ONE AND TWO FAMILY	PLAN REVIEW	CHECKLIST
Soil type/Presumptive Load Value (Table R401.4.1) _____		
Component	Submitted Plan	Findings Revisions Date
STRUCTURAL Footing Dimensions/Depth (Table R403.1 & R403.1(1), (Section R403.1 & R403.1.4.1)	20x10 Concrete footing 8" Concrete wall	OK
Foundation Drainage, Fabric, Damp proofing (Section R405 & R406)	4" Diameter perforated pipe Crushed stone - waterproofing filter fabric	OK
Ventilation/Access (Section R408.1 & R408.3) Crawls Space ONLY	NA	OK
Anchor Bolts/Straps, spacing (Section R403.1.6)	1/2 inch anchor bolts 12 in from corner + 6" max spacing	OK
Lally Column Type (Section R407) Girder & Header Spans (Table R 502.5(2))	~~NA~~ Typical lally into footing - 3k cement filled	
? Built-Up Wood Center Girder Dimension/Type	engineered LVLs (specs incl.)	OK
Sill/Band Joist Type & Dimensions	2x10 PT JOISTS	OK
First Floor Joist Species Dimensions and Spacing (Table R502.3.1(1) & Table R502.3.1(2))	2x10 Floor joist 16"oc	OK

RE: 571 Allen Avenue – 399-E-002 & 003 – R-3 Zone – determination letter

ALLEN AVE
SPEC

PLAN SHOWING A STANDARD BOUNDARY SURVEY MADE FOR
EDWARD DICKHAUT
571 ALLEN AVENUE
PORTLAND MAINE

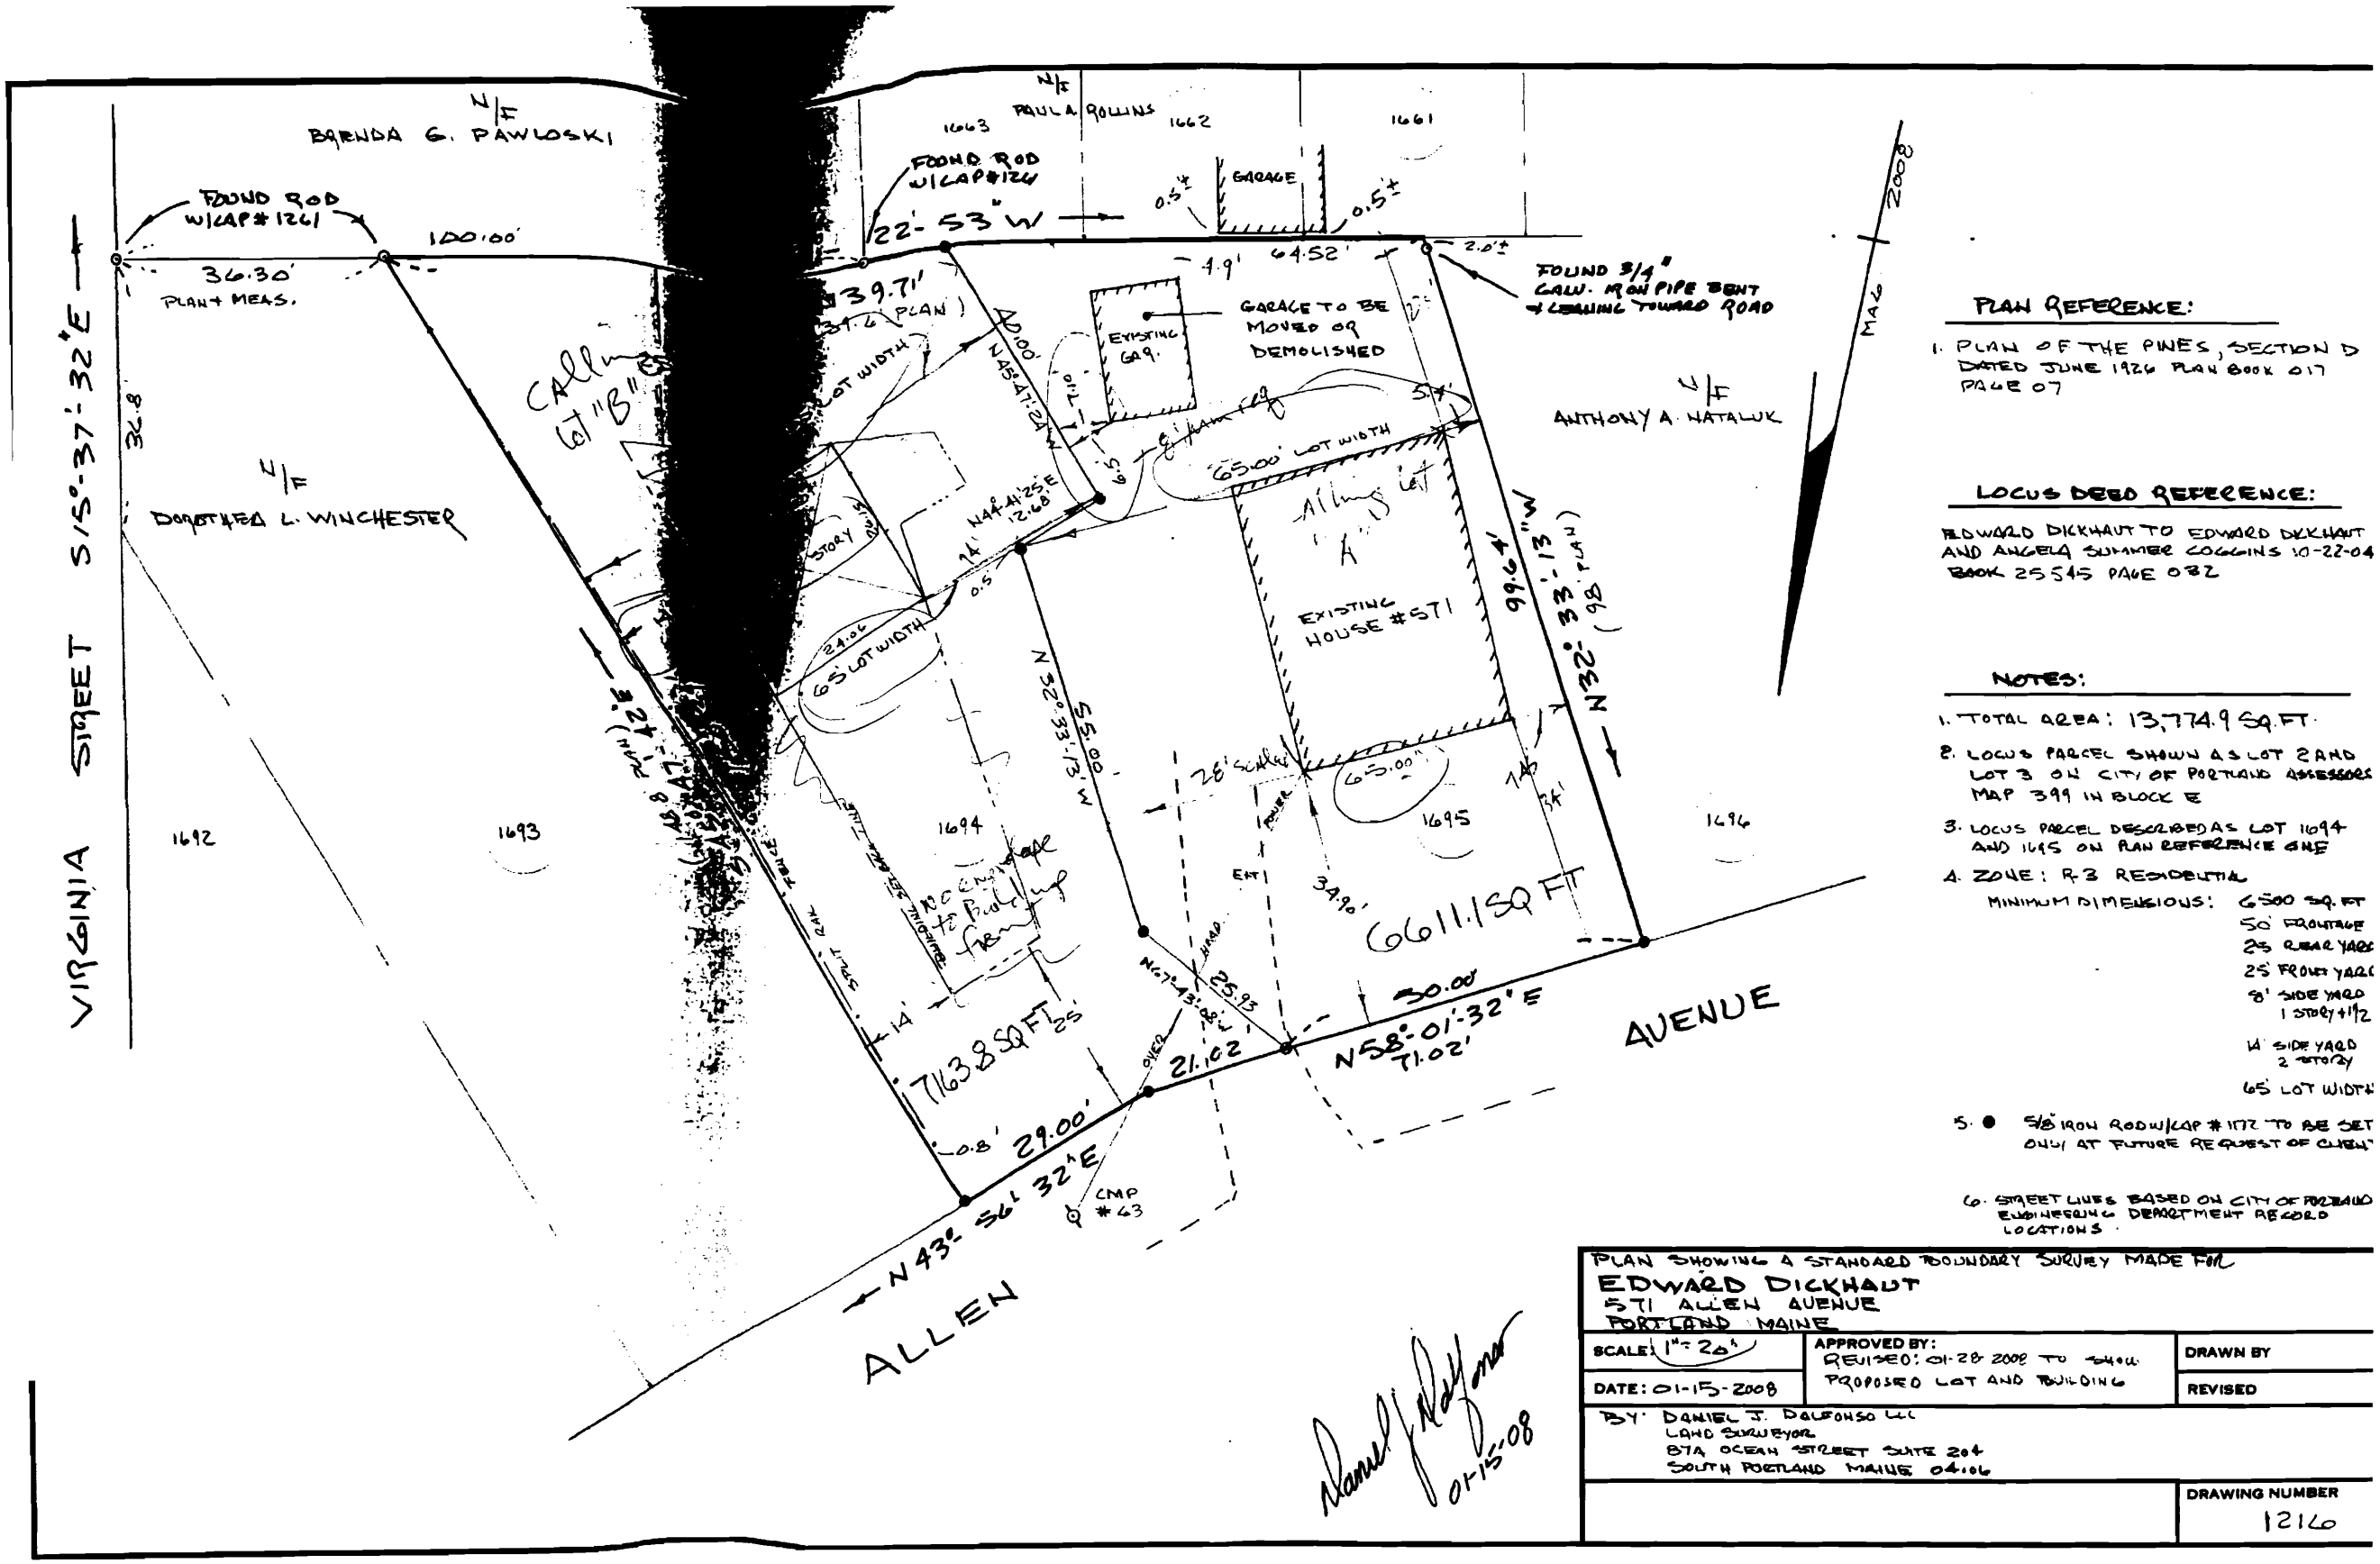
The lot division as proposed does meet the underlying R-3 zoning requirements with several conditions. The existing garage shall be removed prior to final approvals and the selling off of the new lot. The survey plan also erroneously depicts a building setback envelope with in the front area of the new vacant lot where it can not be built upon because it does not have the minimum required lot width. The survey plan shall be revised to eliminate those erroneous building setback lines.

This determination is not an approval to begin construction of any type. If this depicted division is accomplished as shown, separate building permit(s) shall be required prior to any approval and construction. This office will need a copy of the prepared deed description to show compliance with the proposed survey plan. This office shall also receive confirmation that the existing garage has been removed.

09-0775 - garage was removed.
